EXHIBIT G-2
LU 14-0031

PROJECT: 314126-Master Plan Review for ILU
14_0031 (The Highlands)

SUBJECT: Summary of Storm Drainage Master
Plan Peer Review and Comments

FROM: Josh Lighthipe, PE
KPFF Consulting Engineers

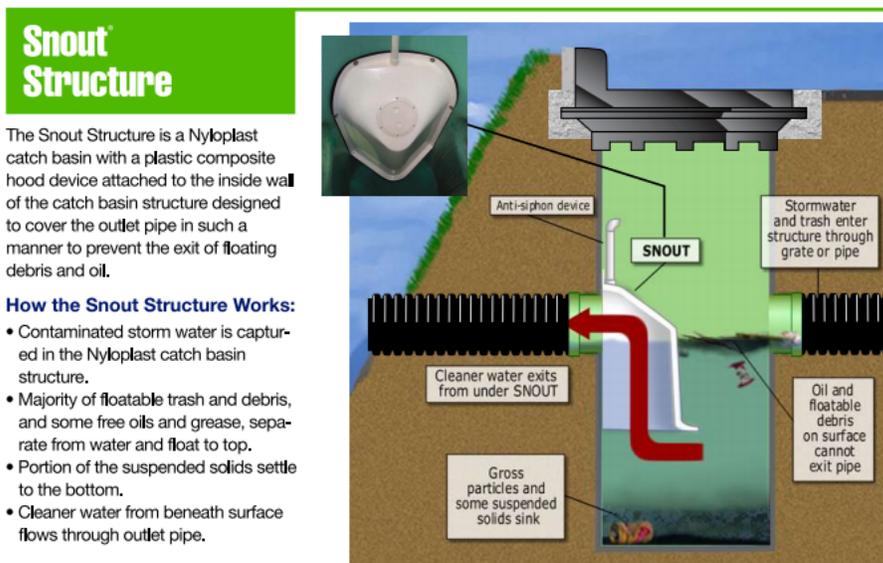
- 2.1 In addition to the sump, the sedimentation manhole should also contain a sediment trap, ideally using a Snout® type product to minimize downstream discharge of sediment and debris, and to ensure that maintenance can be easily performed by City crews. See image of Snout® product within a similar drainage structure below.

EXHIBIT A: Downstream Drainage Areas of Concern

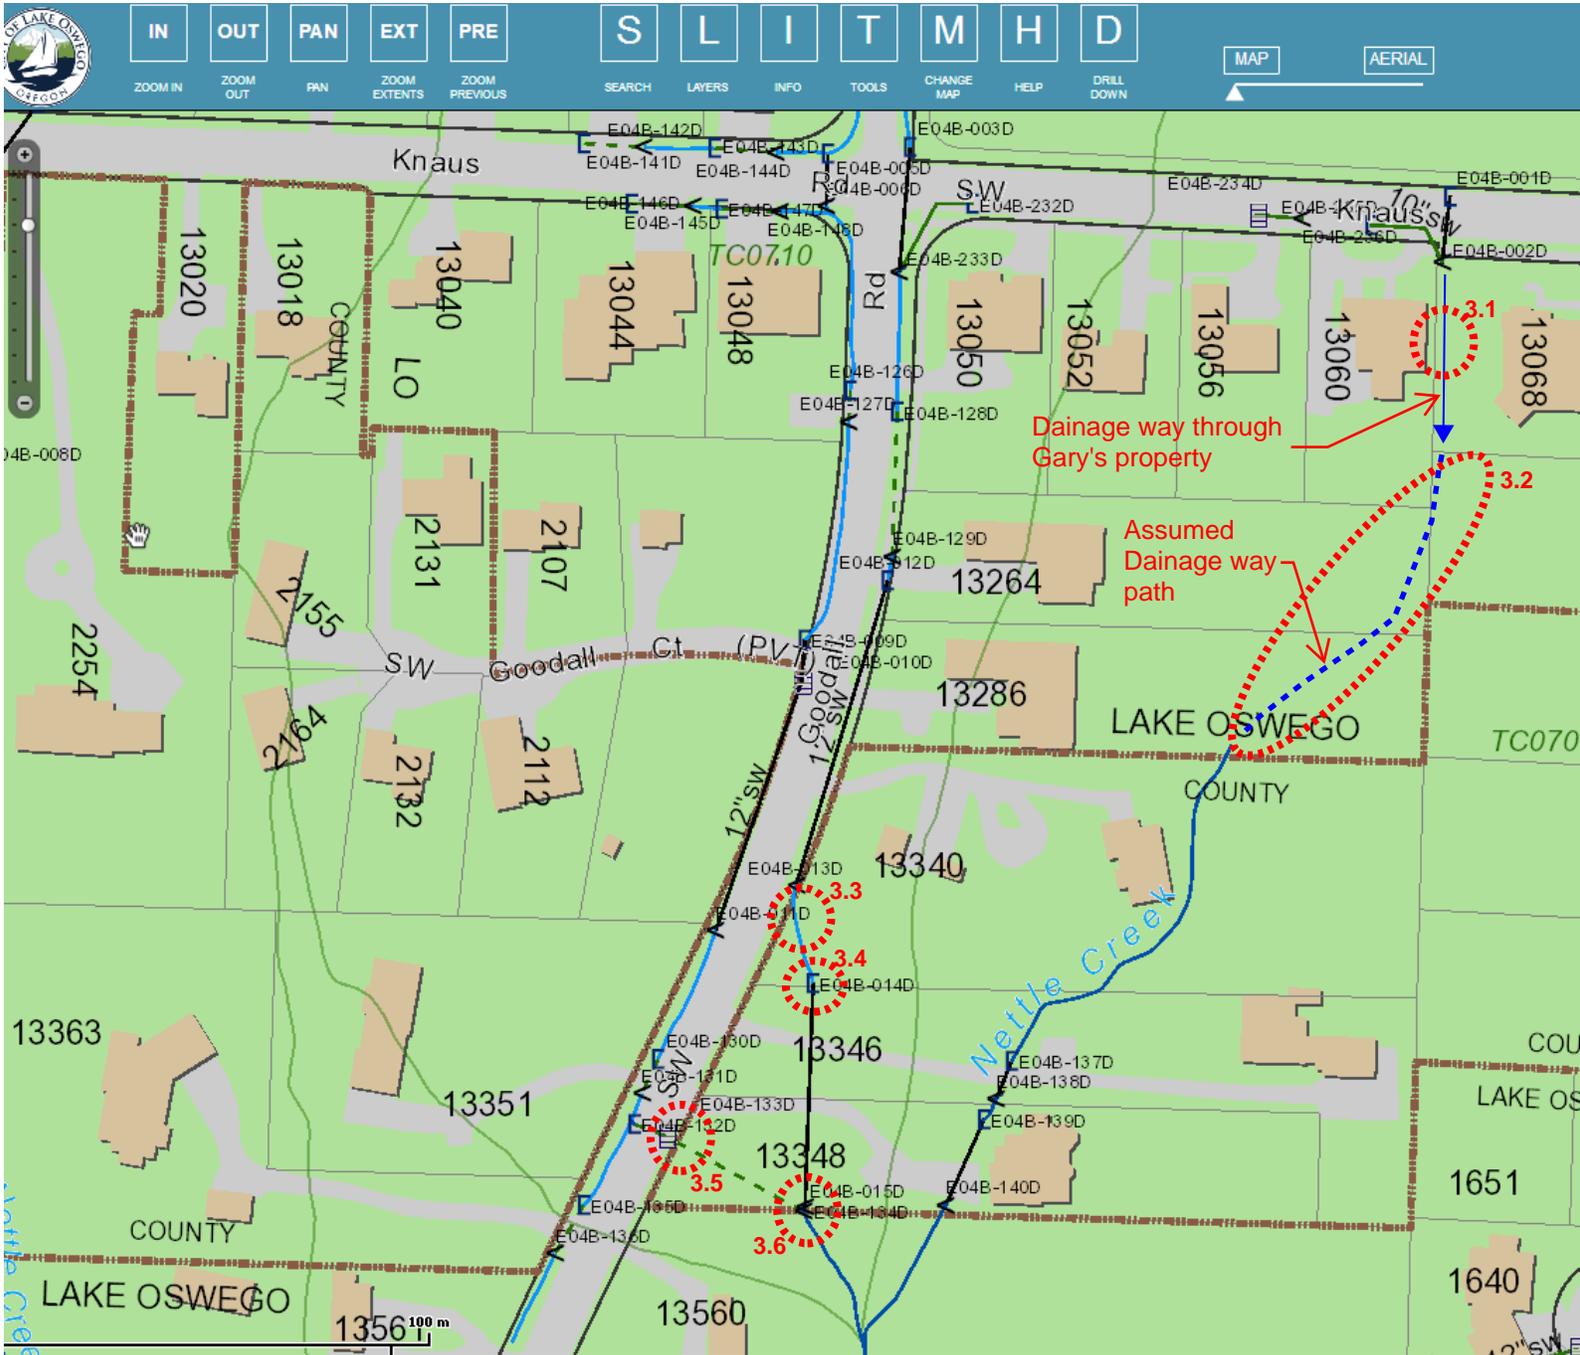
- 3.1 The drainage way flowing though Gary Willihnganz property appears to have some shallower points where it could be possible for water to "jump" its banks and flow out of the channel.

- 3.2 This portion of the drainage way is not managed by the City of Lake Oswego or anyone as far as we know. The flow connection to Nettle Creek indicated on the Exhibit A was assumed, but from the topography it appears likely.

- 3.3 This is the point at which street runoff and all upstream drainage discharges out of pipe outfall and flows across bare ground and beyond the street right-of-way. Round river rock appears to have been placed to slow runoff, but has migrated and significant signs of erosion are apparent throughout area.

- 3.4 Surface drainage enters culvert here. Culvert appears semi-plugged.

3.5 Drainage flows off roadway and misses street catch basin. It appears a neighbor tried to fix this by installing a short fence berm to redirect flows to catch basin.

3.6 Multiple culverts outfall here into concrete trough. Downstream of trough, significant signs of erosion are visible.

Recommendation: Improve and deepen drainage channel to ensure it can handle required drainage capacity.

Recommendation: Visually inspect this portion of the drainage way at least to Nettle Creek if not farther to determine if any erosion or channel capacity issues exist.

Recommendation: Construct defined drainage channel with adequate rip-rap rock armoring and check dams if needed to prevent scouring that connects the drainage flow to the culvert opening (Area 3.4).

Recommendation: Install ditch inlet type of structure over culvert opening to limit potential clogging.

Recommendation: Construct a more permanent and effective solution for this area to collect street runoff and convey it to the catch basin.

Recommendation: This area should be protected with appropriate amount of rip-rap to prevent further downstream erosion.
